SAFETY EVALUATION REPORT

OFFICE OF NUCLEAR REACTOR REGULATION
SUPPORTING AMENDMENT 21 TO FACILITY
OPERATING LICENSE NO. DPR-34

PUBLIC SERVICE COMPANY OF COLORADO
FORT ST. VRAIN NUCLEAR GENERATING STATION
DOCKET NO. 50-267

Fig. . Relative axial locations of in-core instrumentation

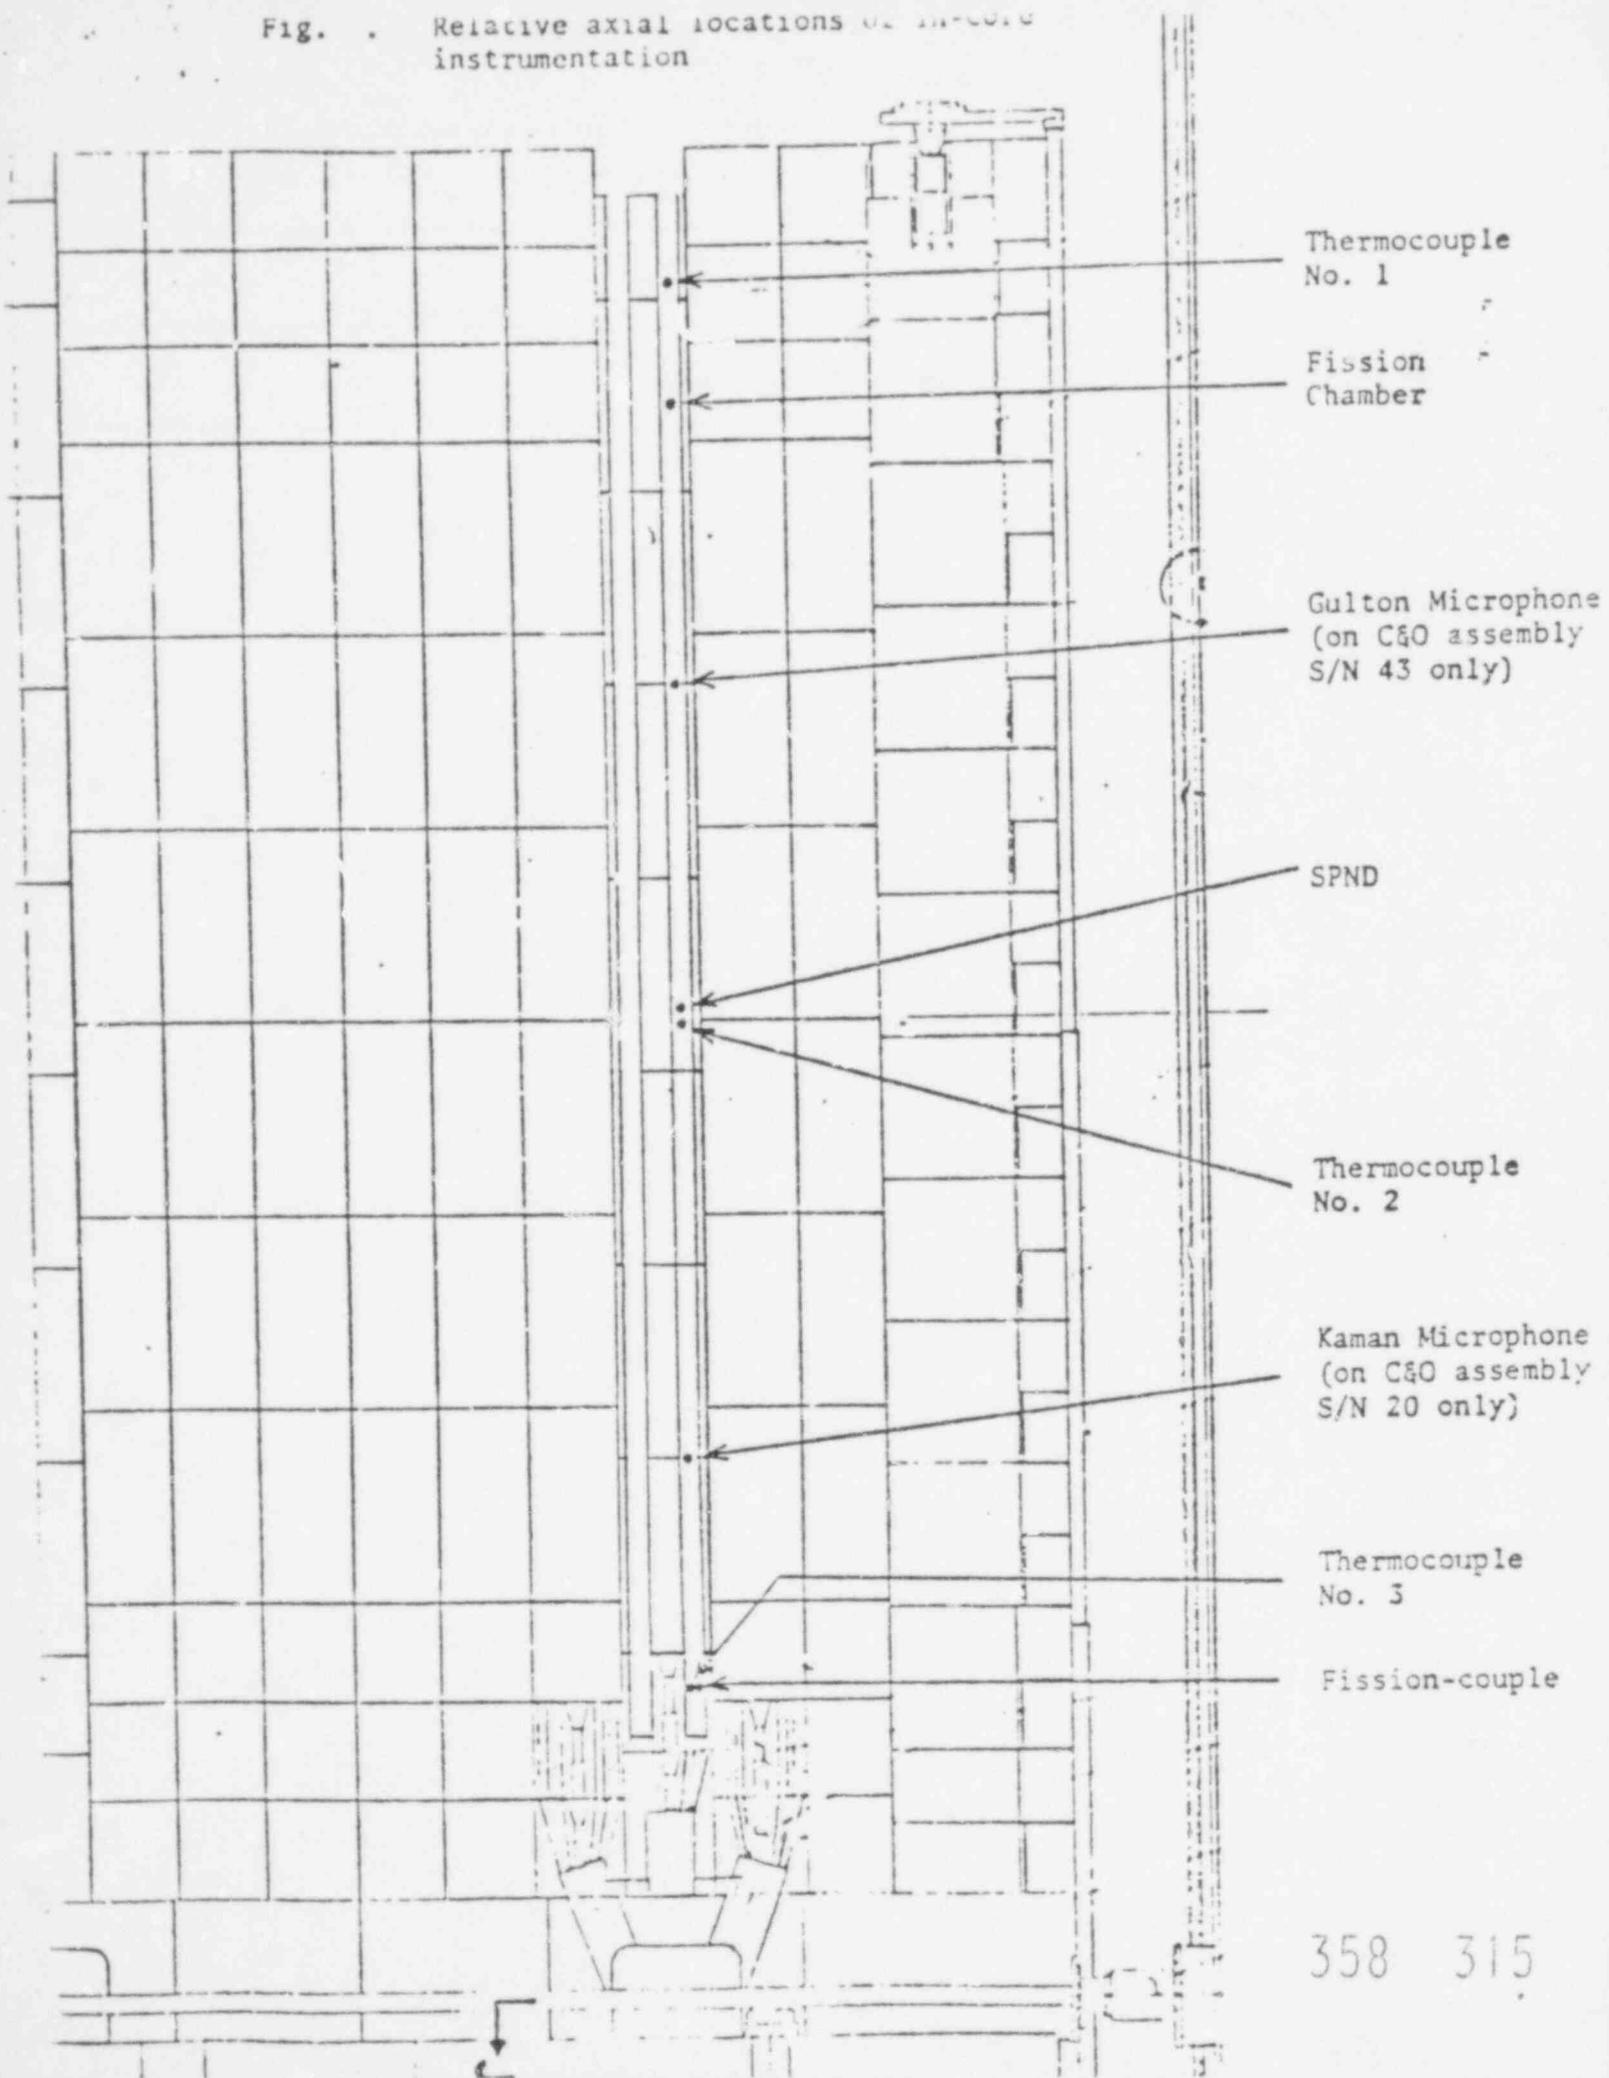
We have reviewed the proposed modifications with regard to their effect on those aspects of core neutronic and thermal-hydraulic behavior important to reactor safety.

Mechanical failure of an instrument package is analogous to the failure of a control rod. The bottom of the instrument package has been designed such that in the unlikely event of a failure, the exit to the control rod channel would not be blocked preventing the flow of coolant. Nevertheless, thermal and fuel performance analyses have been performed assuming the instrument assembly drops to the bottom of the channel and completely blocks the coolant flow while the plant is operating at full power. These analyses show that, even under these severe conditions and if the failure of the instrument assembly went unnoticed for 40 hours, the instrument package would not melt and the impact on fuel performance would be negligible. If the instrument package should fail, the failure would result in anomalous readings which would give indication of such a failure. Also, the bottom of the instrument package has been designed to act as a catcher for small parts, should an unlikely occurrence of that nature happen.

The presence of the instrument package in the control rod channel will have an insignificant effect on the normal helium flow through the channel. Calculations indicate that the flows through the channel containing the instrument package, through the corresponding channel with the control rod inserted, are within 10%. These conclusions result from a comparison of the relative flow resistances for these cases. The values of flow resistance for the instrument package and for the control rod were determined by means of full-scale flow tests.

We conclude, based on the analyses and data presented, that the use of the instrumented assembly of the Instrumented Control Rod Drive (ICRD) assembly has a minor effect on the flow through the control rod channel. We conclude also that the temporary modifications to the closure assemblies to accommodate instrument leads will not affect the performance or integrity of the closures.

Figure 6.1
LCO 4.3.9, High Pressure Helium Supply System

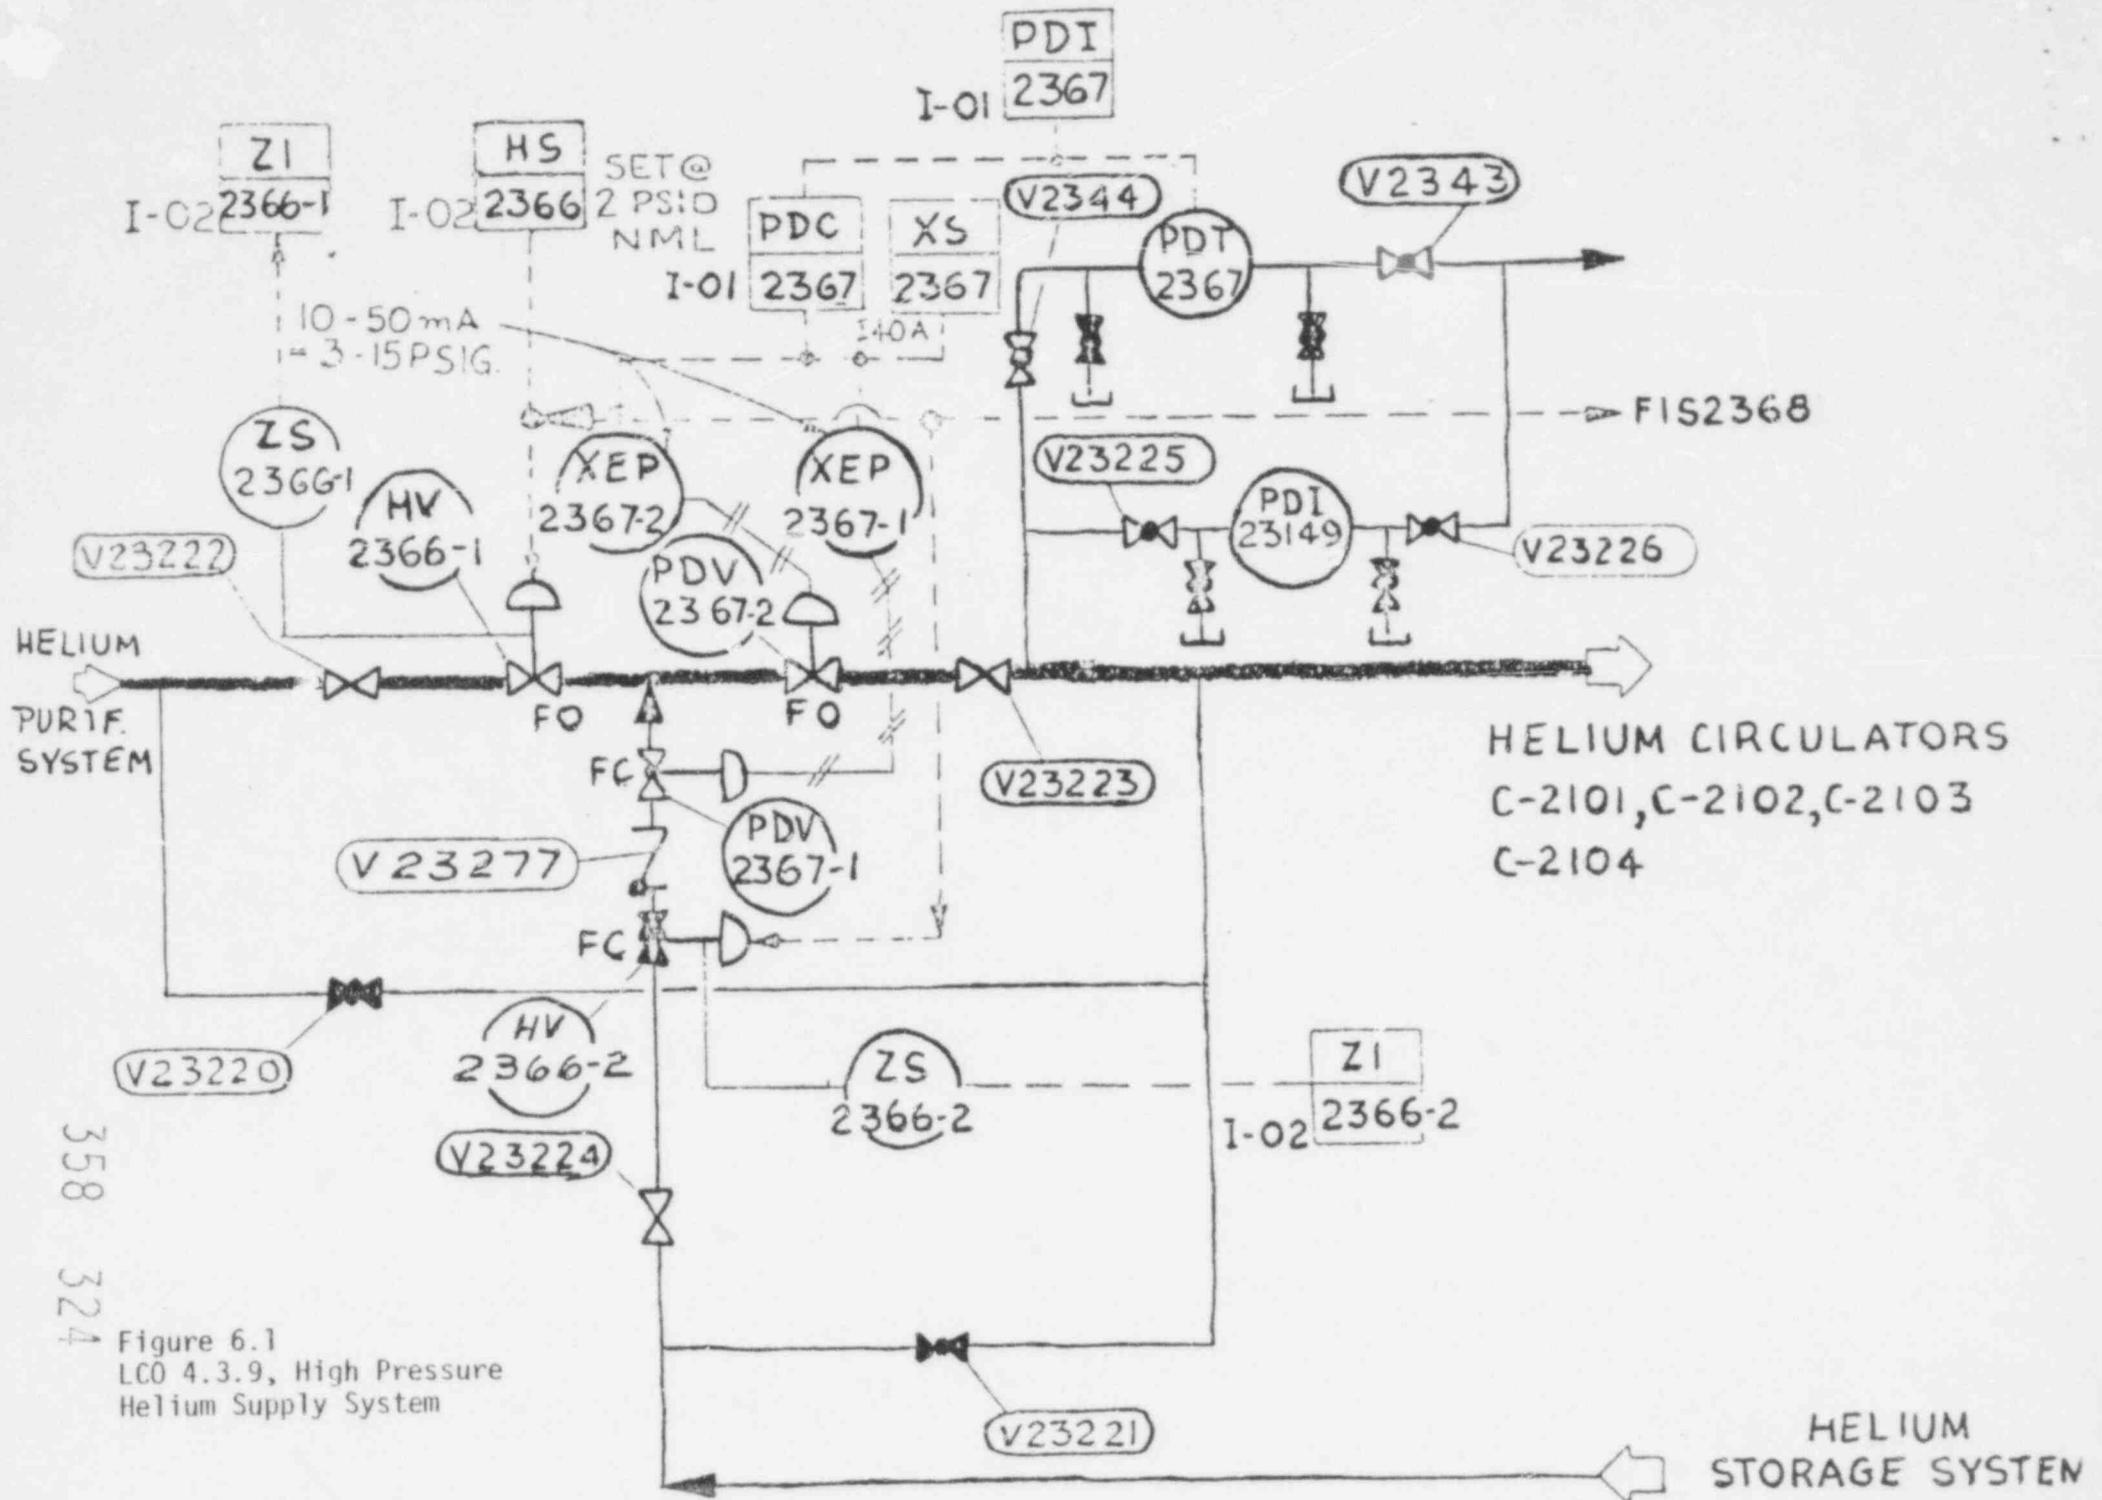
Technical Specification LCO 4.3.9, as written, insures against the unwanted accident flow only in the case of a double casualty, namely loss of purified helium flow followed by failure of the PDC-2367-1 valve to regulate pressure by accidentally being energized to the wide open position. However, with the LCO as written, a sequence of events could happen when the high-pressure storage bottle system is used, which could cause a circulator trip. This is the type of occurrence which the LCO set out to specifically avoid.

We have reviewed the system design and pertinent information in the failure mode of pressure regulatory valve. We conclude that the present design of the instrumentation and controls for the system which provides buffer helium makeup from the helium storage bottle system requires two separate failures which could result in the loss of buffer helium to the

circulators. Therefore, since the design now satisfies the single failure requirements, we find it acceptable. Accordingly the proposed deletion of LCO 4.3.9 is acceptable.
